TenneT Submission on E3grid2012 and STENA2012

COMMENTS FROM FRONTIER/SUMICSID/CONSENTEC

ACM received a submission from TenneT with regard to the benchmarking analysis underlying ACM's draft Method Decision. TenneT raised 6 topics in their submission. In this note we discuss these topics and refer to the respective section in the e3grid2012 final report[1].

Figure 1. Development of distribution of efficiency scores

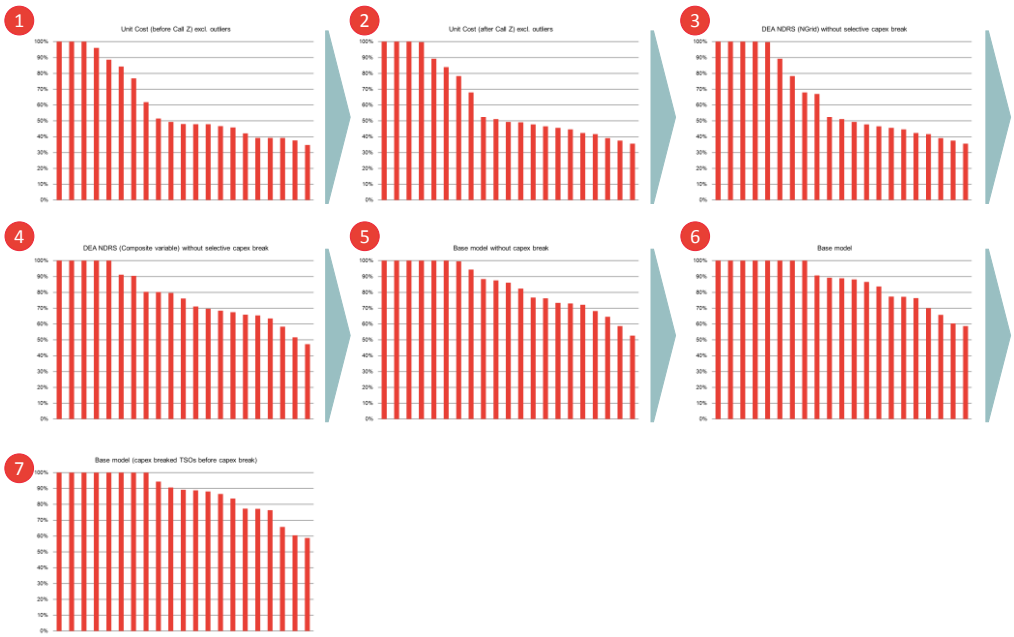
Figure 1 shows the development of the distribution of efficiency scores for the different steps.

The unit cost model shows a distribution which can be characterised as half-normal, i.e. a step tail which fades out at the lower end. The distribution is rather smooth. The following steps result in an increase of the efficiency scores on the lower end. In step 5 the efficiency scores show a distribution which TenneT may call a "normal distribution". The distribution of the efficiency scores is smooth with no grouping of TSOs in some efficiency ranges.

Step 6 includes the selected capex break which was introduced as a further DEA outlier analysis to ensure that the efficiency frontier spanned by the peer companies sets feasible cost targets that are not unduly influenced by the absence of historical investment data. This additional adjustment works in favour of companies not (yet) 100% efficient and pushed further TSOs to the efficiency frontier and increased the average efficiency by 2%. However, based on the logic from TenneT we should have forgone this step – that favours certain TSOs – because the resulting distribution of efficiency scores is not a "normal distribution" any more. This shows that the "smooth" distribution of efficiency scores in DEA must not be seen as a given, but other considerations are more valuable.

Step 7 illustrates the distribution of efficiency scores for the e3grid2012 base model using the efficiency scores for the 2 Capex breaked TSOs before Capex break was applied. The distribution looks "normal" again as the drop between the 100% companies and the next inefficient company narrows down.
